**LEXINGTON-FAYETTE URBAN COUNTY
 GOVERNMENT CONTRACT CHANGE ORDER**
 Page 1 of 2

Date:	January 19, 2017
Project:	Investigation/Design Services for Town Branch WWTP Primary Digester Complex Improvements
Location:	Town Branch WWTP

JUSTIFICATION FOR CHANGE

Re: Town Branch Primary Digester Complex Improvements

1 PLAN - DIGESTER CONTROL BUILDING ROOF

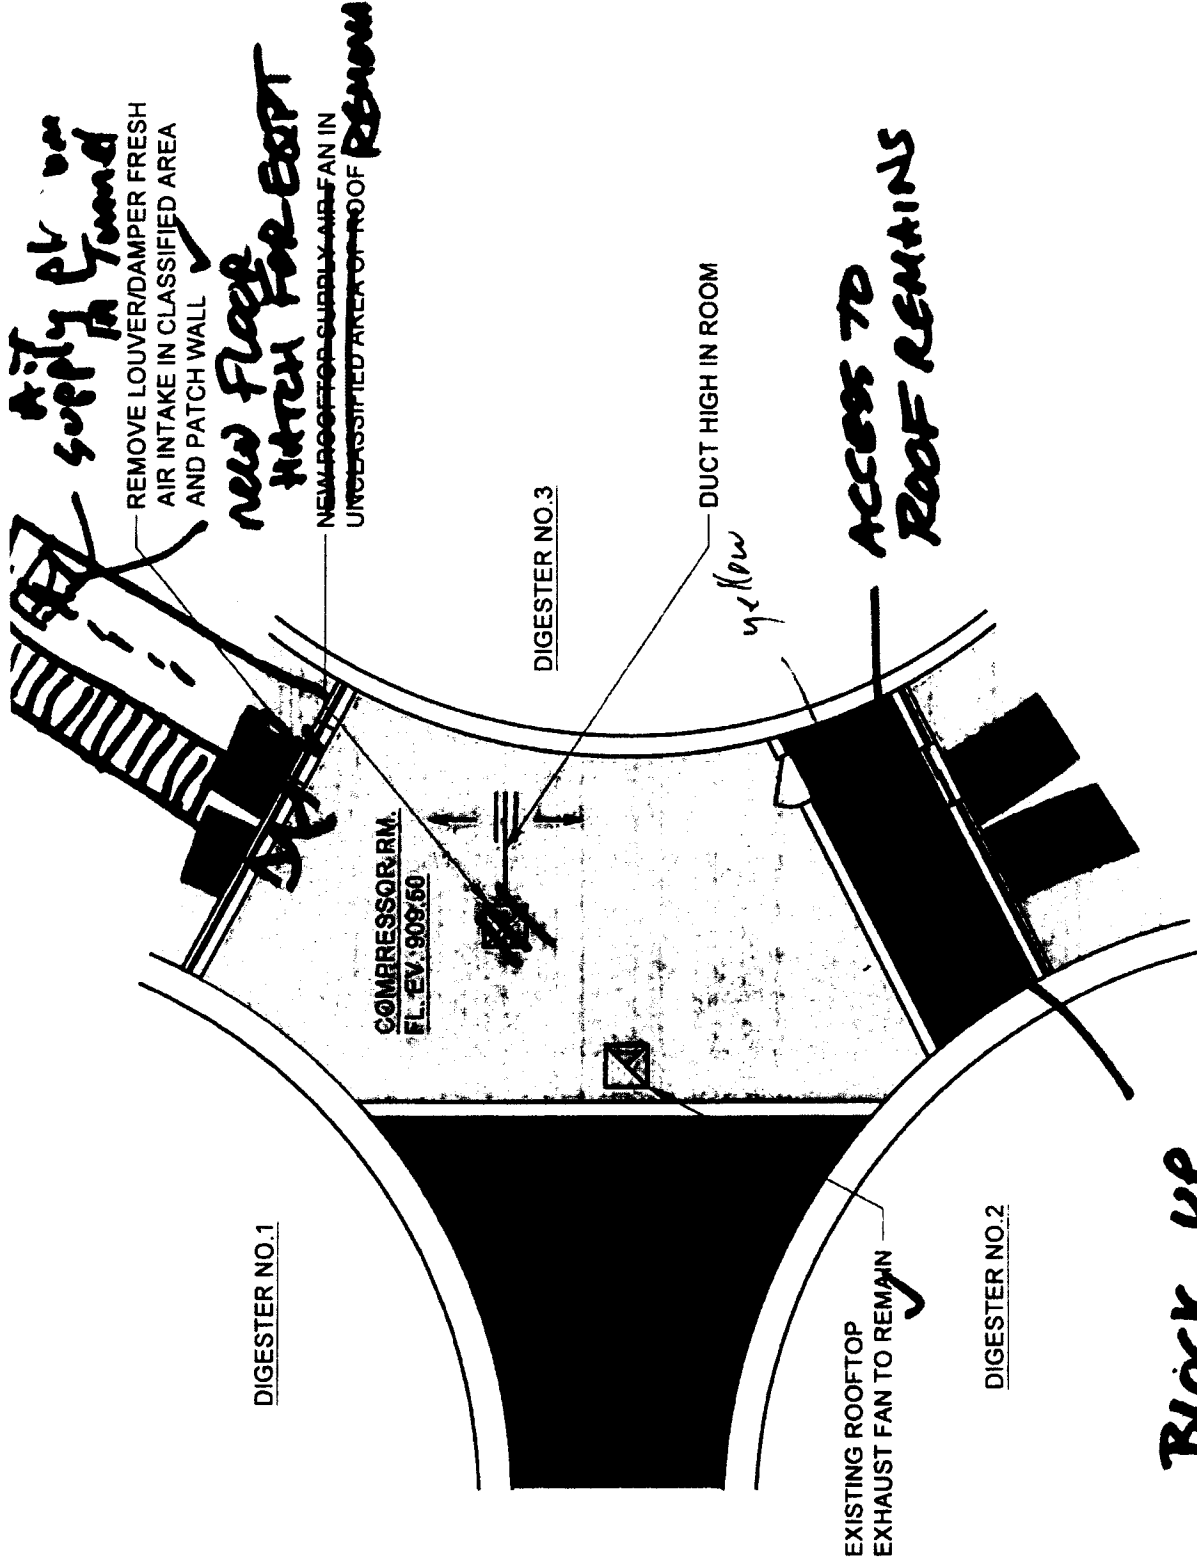
REMOVE ROOF TOP SUPPLY FAN FOR BOILER ROOM, SEAL ROOF AND PROVIDE NEW FAN IN UNCLASSIFIED AREA

RELOCATE GAS FLUE VENTS TO UNCLASSIFIED AREA

ROOF @ ELEV. 909.5
REMOVE SUPPLY FAN AND PATCH ROOF

REMOVE GRAVITY INTAKE VENT FOR FIRST FLOOR COMPRESSOR ROOM AND PATCH ROOF

REMOVE SUPPLY FAN AND PATCH ROOF

REMOVE GRAVITY VENTILATORS AND PATCH ROOF

REMOVE GRAVITY INTAKE VENT FOR BASEMENT GAS PIPING ROOM PATCH ROOF

EXISTING SUPPLY FAN FOR MEZZANINE ~~AREA~~ TO REMAIN ~~EXISTING~~

NEW ROOF TOP SUPPLY FAN FOR COMPRESSOR ROOM

1 PLAN - MEZZANINE FLOOR COMPRESSOR ROOM
 ELEV. 909.50

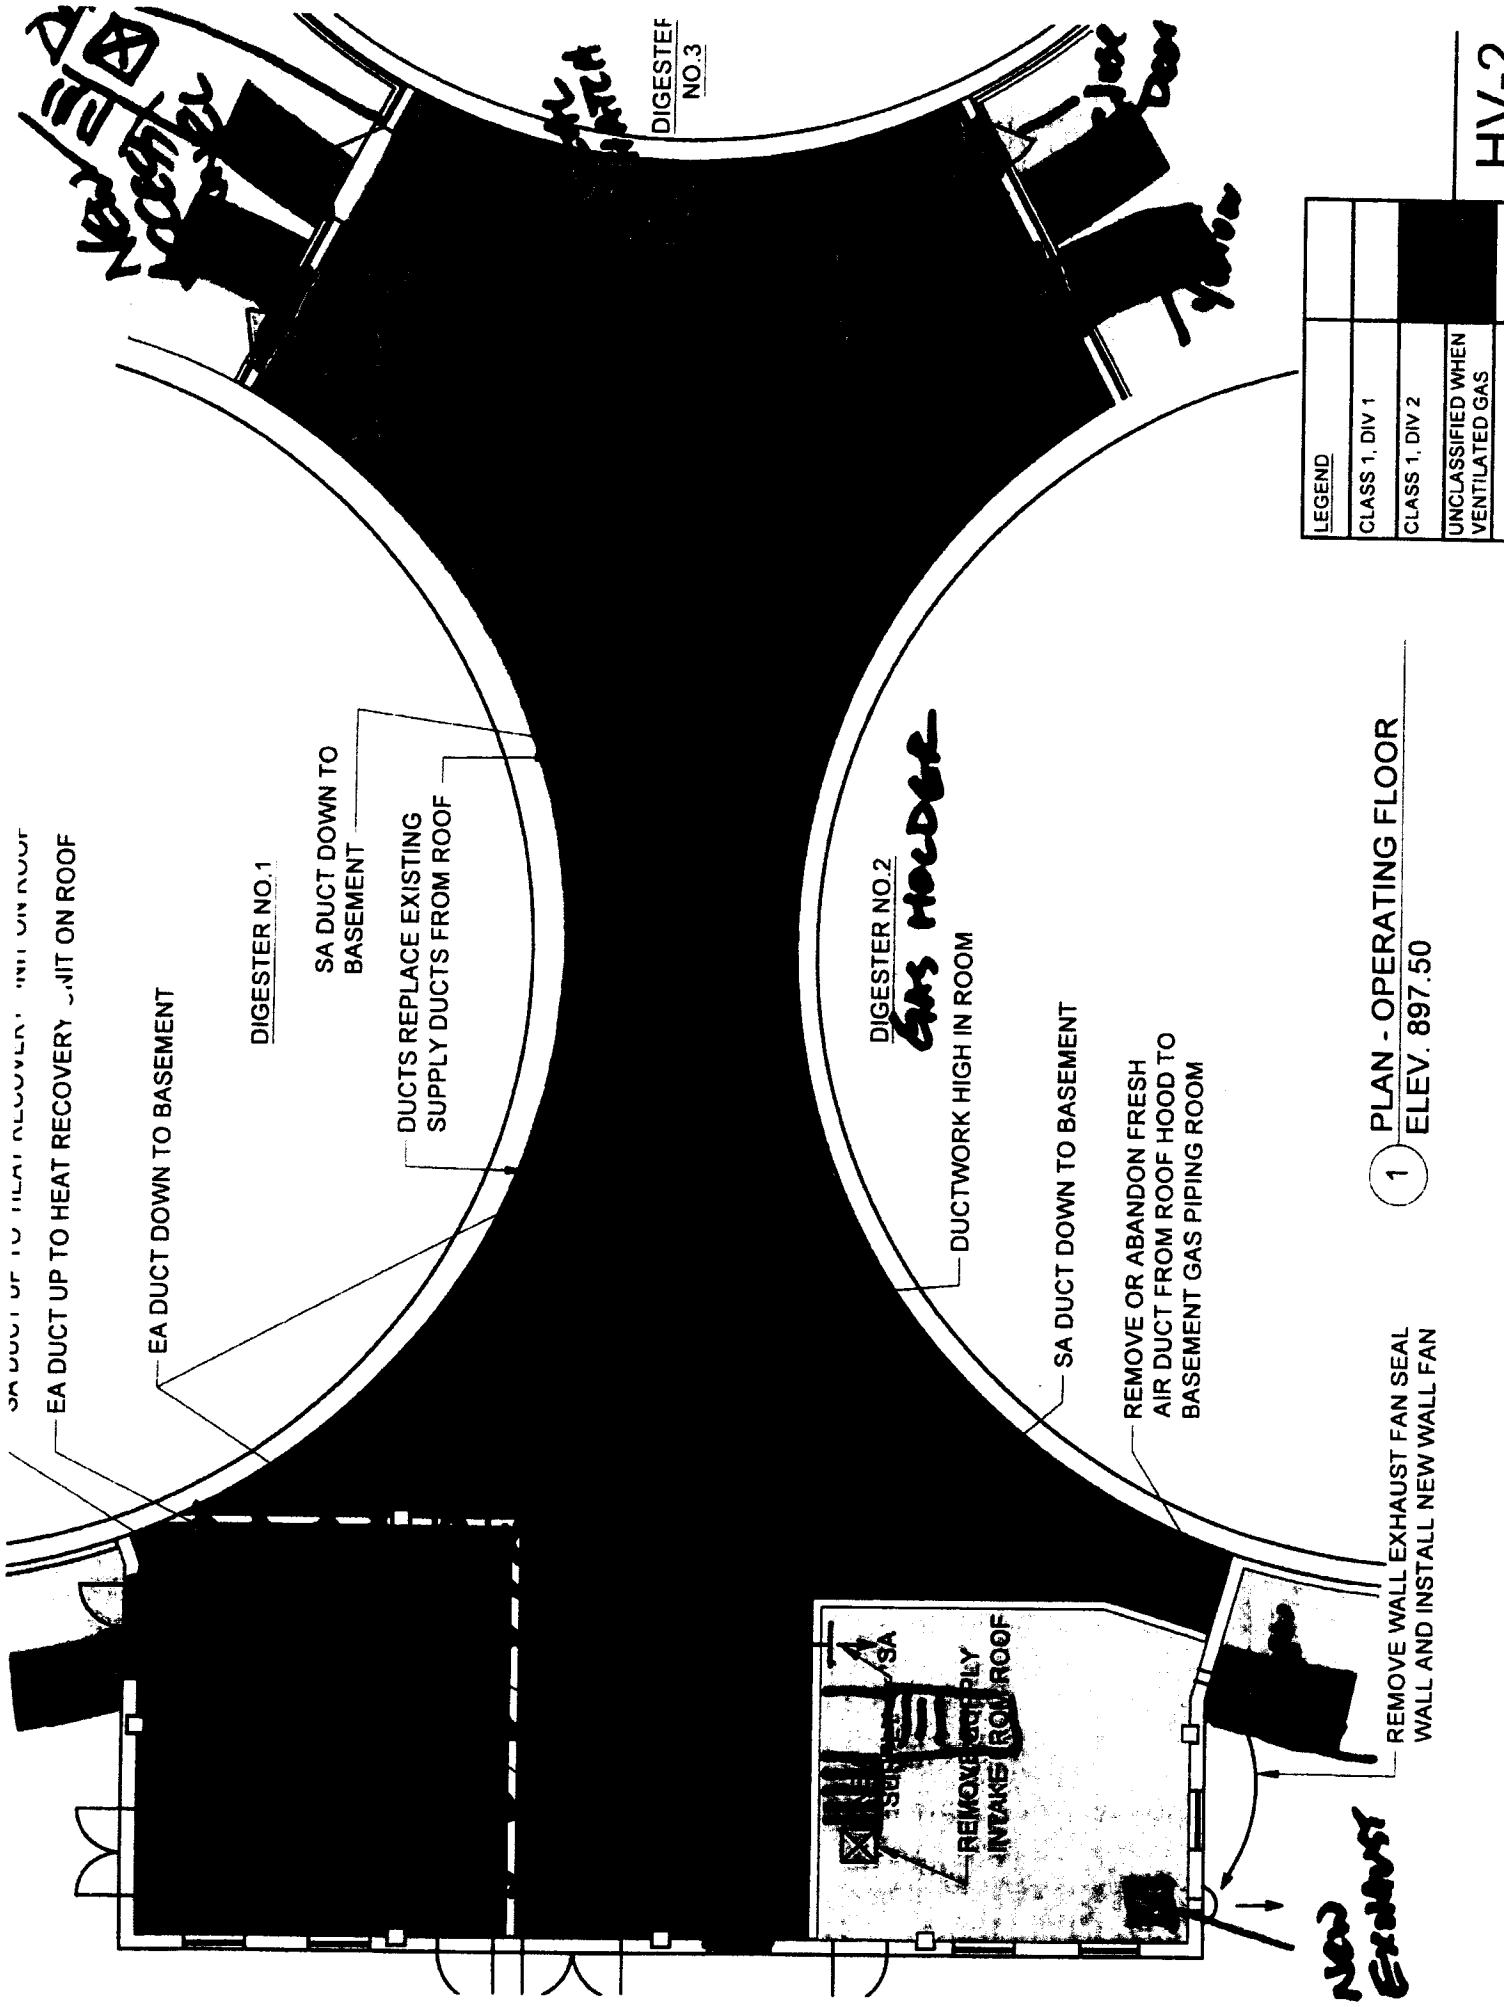
NEW EXHAUST

REMOVE LOUVER/DAMPER FRESH AIR INTAKE IN CLASSIFIED AREA AND PATCH WALL

new floor hatch for east
 new rooftop supply air fan in unclassified area of roof remains

EXISTING ROOFTOP EXHAUST FAN TO REMAIN

Block up STAIRWELL FLOOR TO SEPARATE SPACES

1 PLAN - OPERATING FLOOR
 ELEV. 897.50

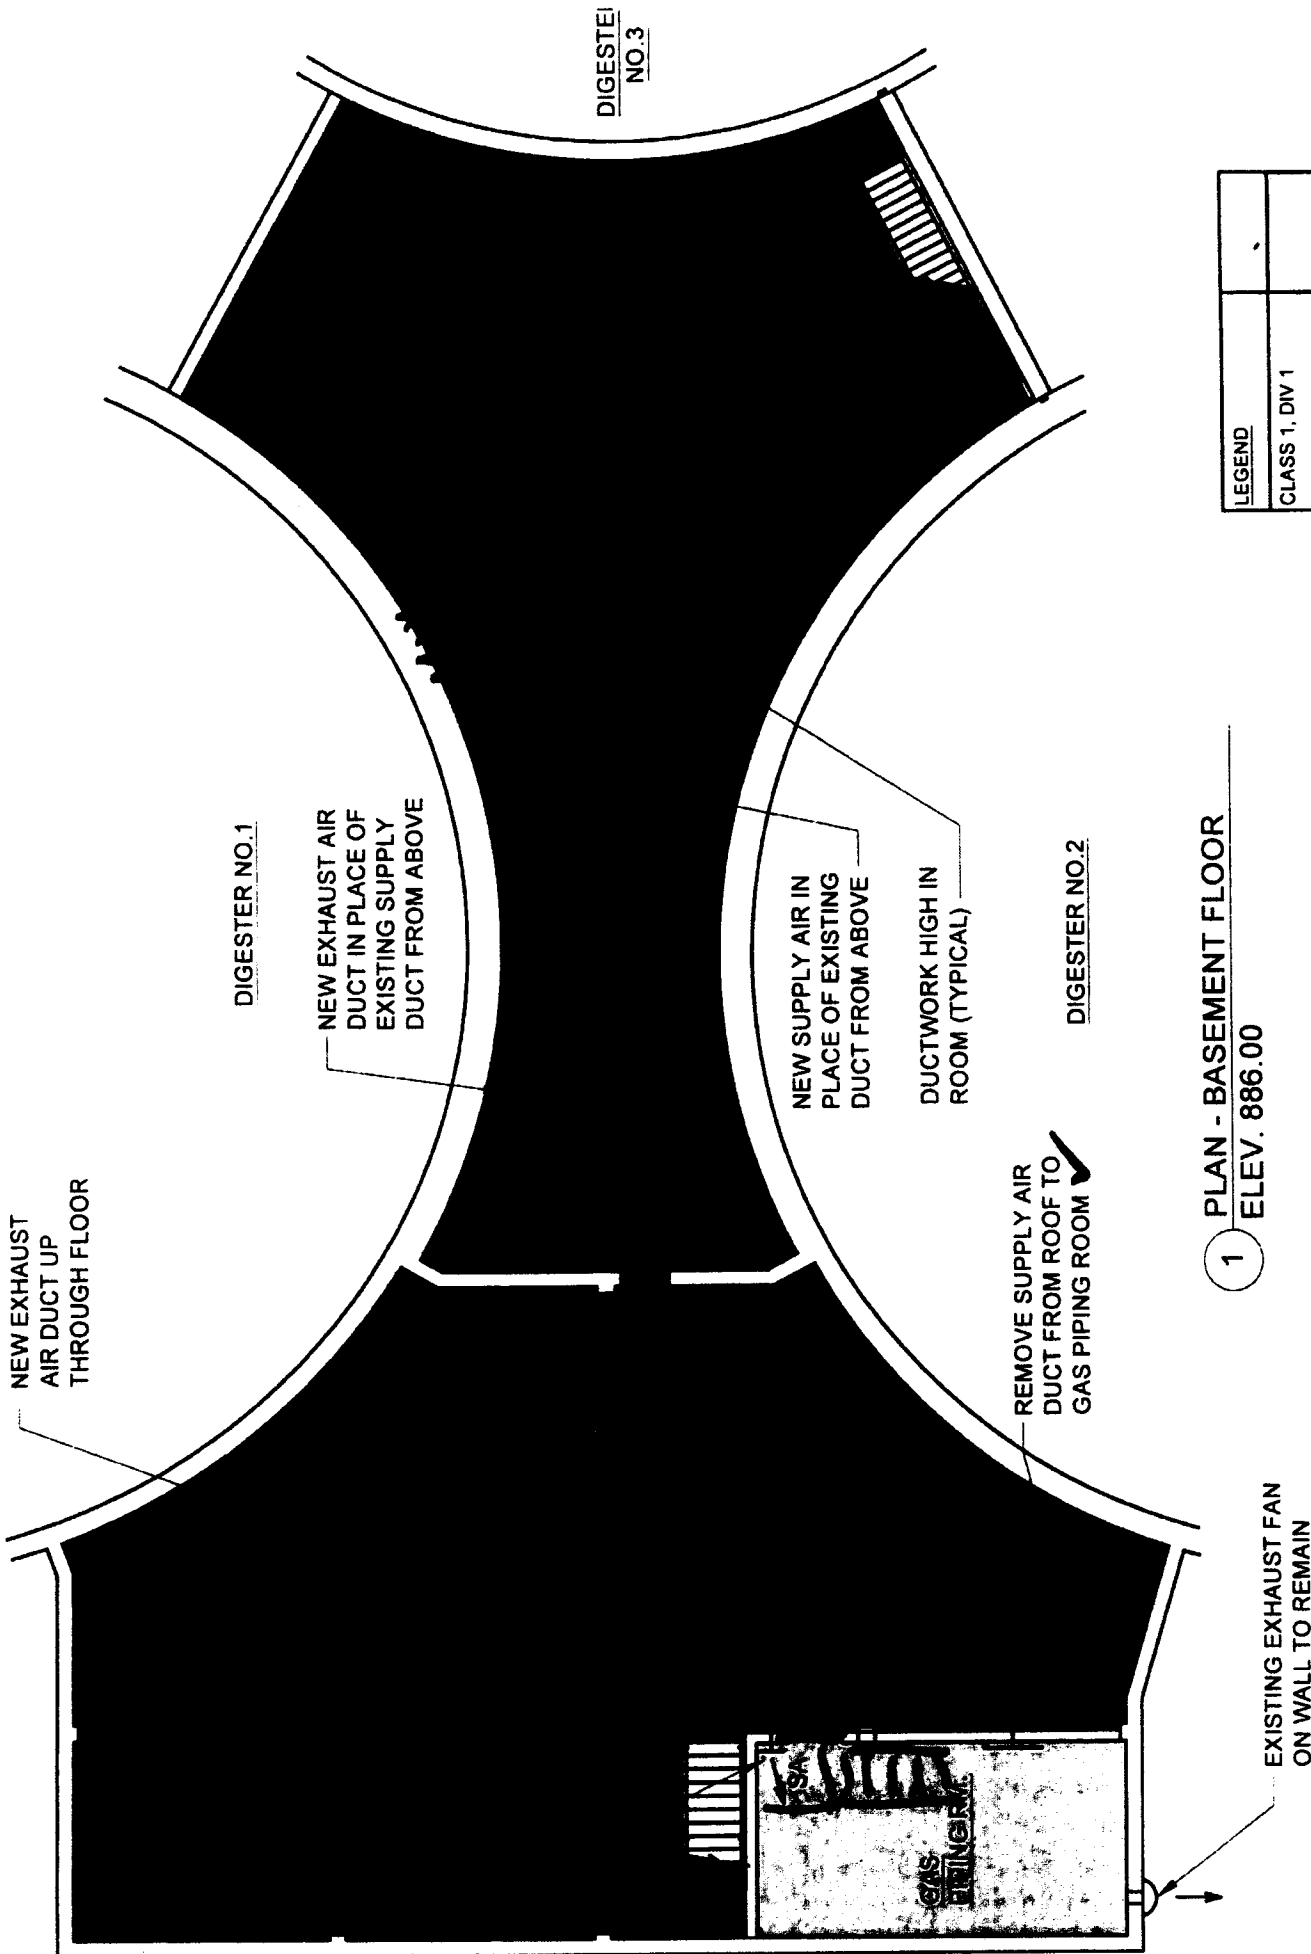
SA DUCT UP TO HEAT RECOVERY UNIT ON ROOF
 EA DUCT UP TO HEAT RECOVERY UNIT ON ROOF

EA DUCT DOWN TO BASEMENT

SA DUCT DOWN TO BASEMENT

DUCTS REPLACE EXISTING SUPPLY DUCTS FROM ROOF

Close Door

REMOVE OR ABANDON FRESH AIR DUCT FROM ROOF HOOD TO BASEMENT GAS PIPING ROOM

REMOVE WALL EXHAUST FAN SEAL WALL AND INSTALL NEW WALL FAN
